973 500 051 0 Installation Instructions

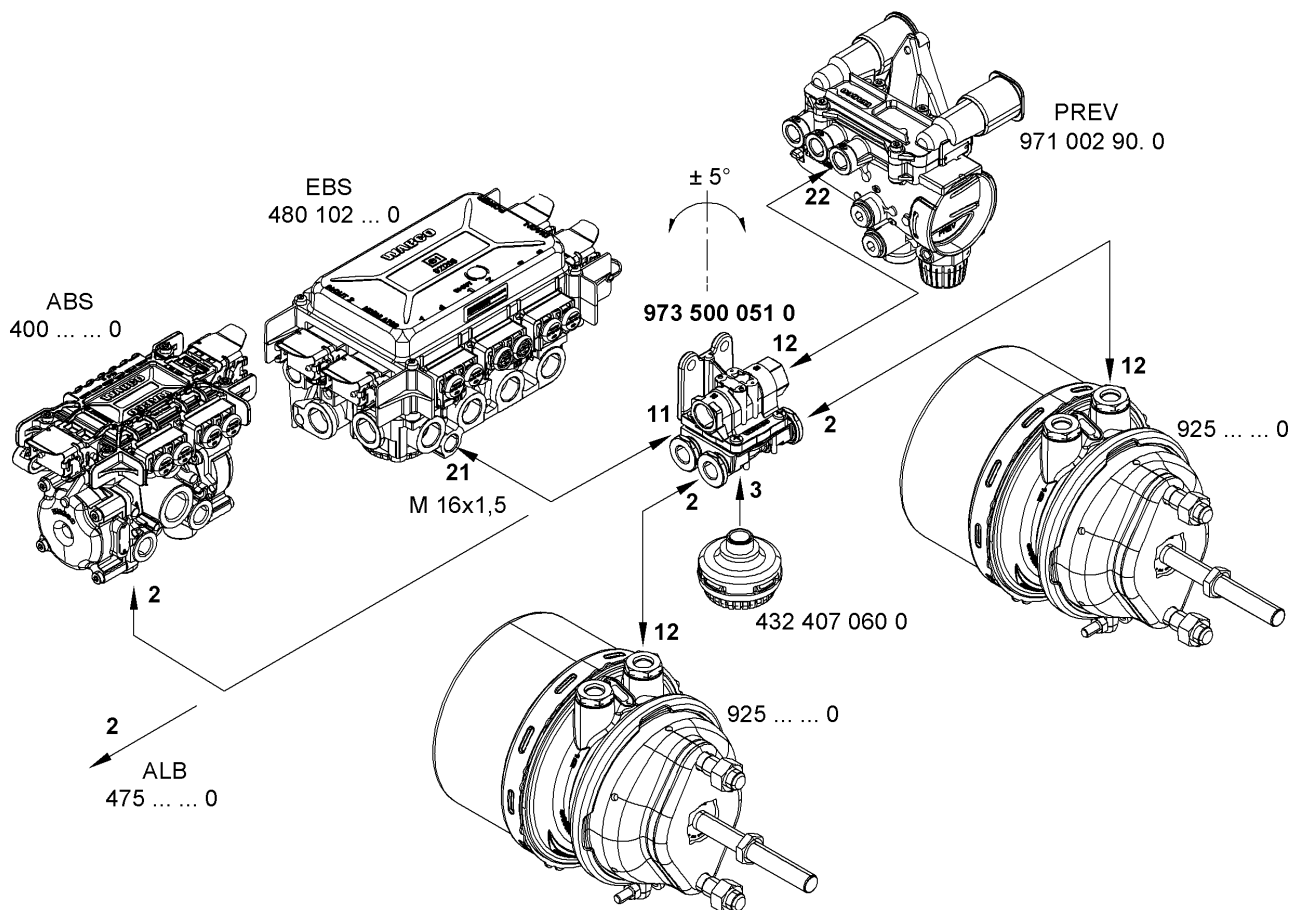
When fitting the quick release valve 973 500 051 0 manufactured later than production week 11/06, as replacement or into new vehicles, the port assignment with regard to ports 11 and 12 must follow to the scetch shown below.

The reason for this is an additional spring which fixes the piston into a secure position. Mixing up the ports might cause venting air at the exhaust of both LSV or EBS modulator. This would be no fault at these devices.

The installation position of the quick release valve shown is +/- 5° max deviation.
